SUBJECT: SURRY UNITS 1 AND 2 - ISSUANCE OF AMENDMENTS RE: GASEOUS EFFLUENT
RELEASE POINT (TAC NOS. 80063 AND 80064)

Amendment No. 157
License No. DPR-32

SAFETY EVALUATION BY THE OFFICE OF NUCLEAR REACTOR REGULATION
RELATED TO AMENDMENT NO. 157 TO FACILITY OPERATING LICENSE NO. DPR-32
AND AMENDMENT NO. 156 TO FACILITY OPERATING LICENSE NO. DPR-37

VIRGINIA ELECTRIC AND POWER COMPANY
SURRY POWER STATION, UNIT NOS. 1 AND 2
DOCKET NOS. 50-280 AND 50-281

**FIGURE 5.1-1
MAP DEFINING UNRESTRICTED AREAS FOR RADIOACTIVE
GASEOUS AND LIQUID EFFLUENTS**

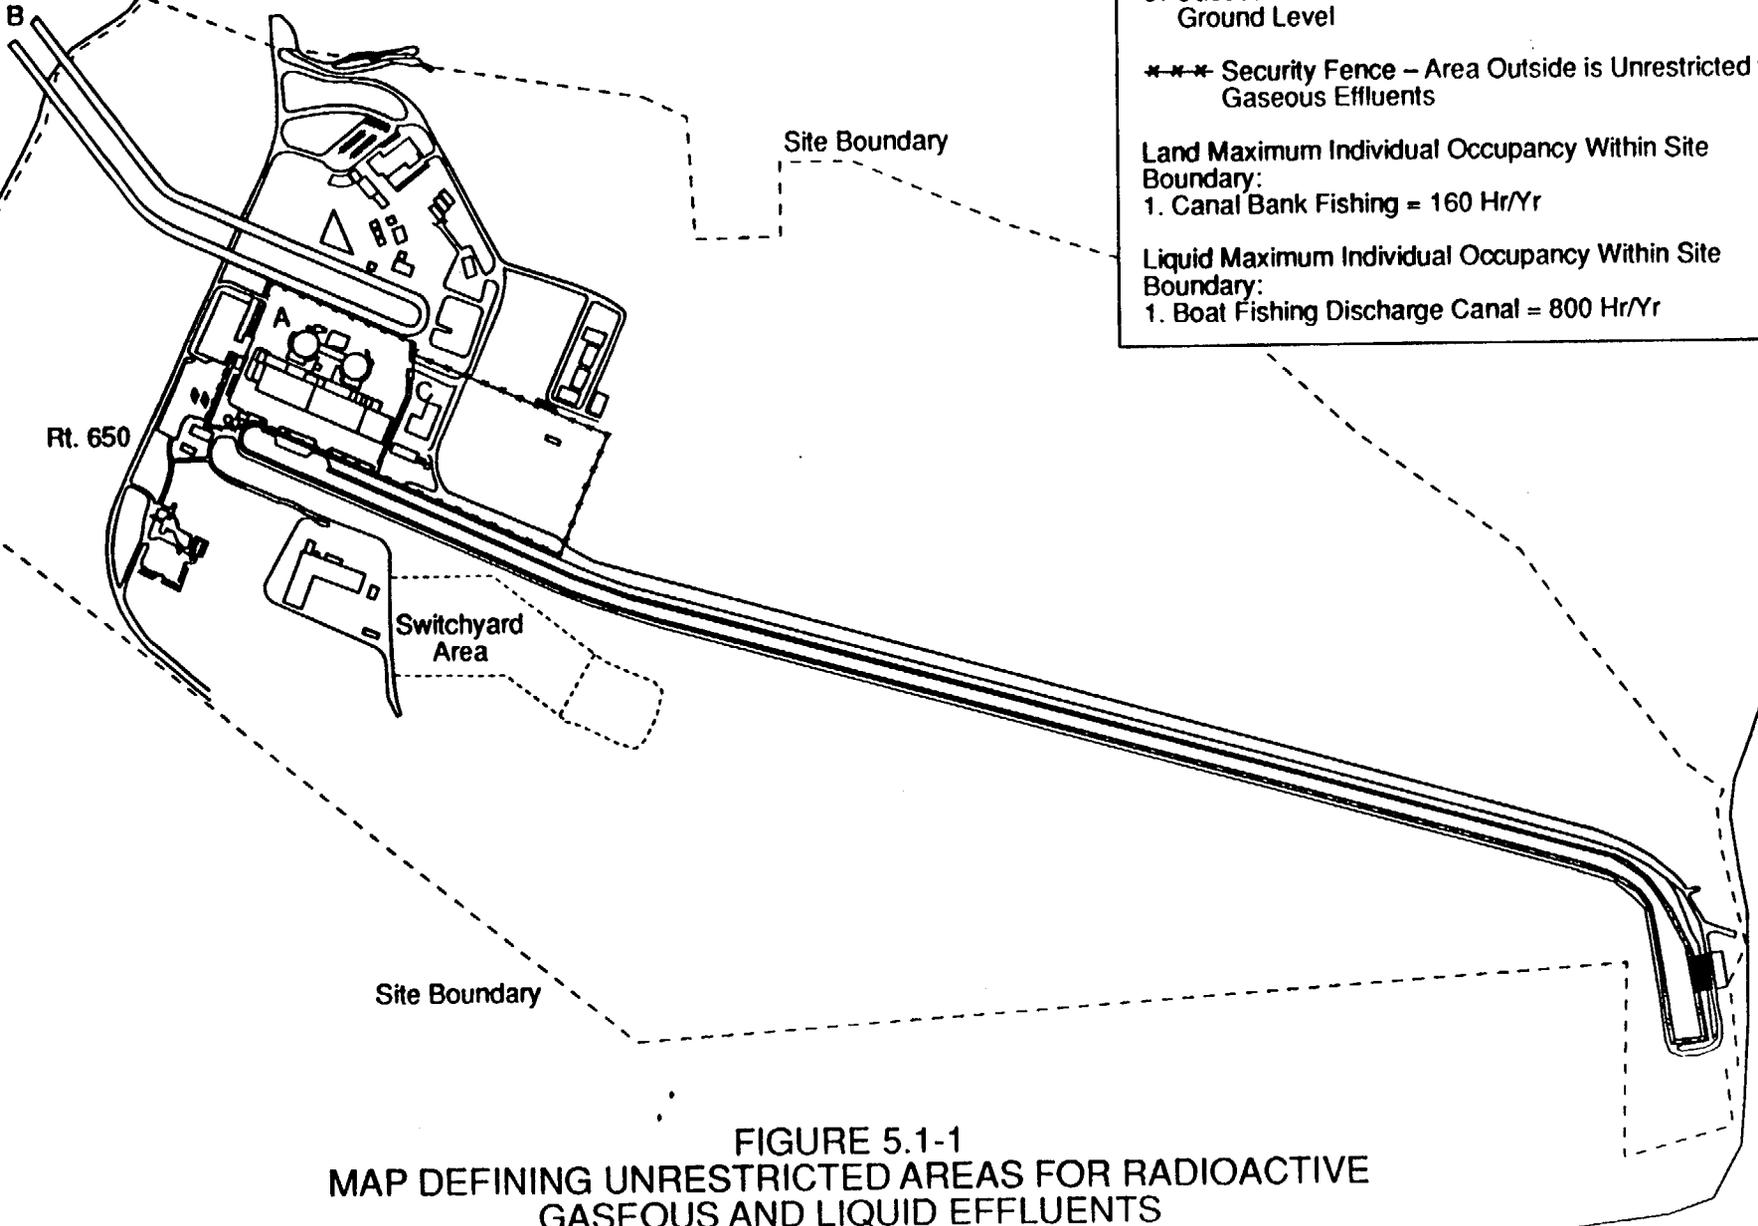
These amendments incorporate the location of the gaseous effluent release point associated with the newly constructed Radwaste Facility into Figure 5.1-1. In addition, a station process vent is also identified as a mixed mode release point.

- A. Gaseous Release
 1. Process Vent - 131 Ft. - Mixed Mode
 2. Vent-Vent Stacks
Ground Level

- C. Gaseous Release
Ground Level

By letter dated March 27, 1991, Virginia Electric and Power Company (the licensee) requested amendments to the Surry, Units 1 and 2 Technical Specifications (TS). The proposed changes would incorporate the location of the gaseous effluent release point associated with the newly constructed Radwaste Facility into Figure 5.1-1 of the TS. A station process vent would also be identified as a mixed mode release point.

Additionally, the station process vent at a 131 foot elevation is being identified as a mixed mode release point, i.e., both elevated and ground level dispersion components are accounted for. This vent has been treated as a mixed mode release point but never identified as such in the TS.
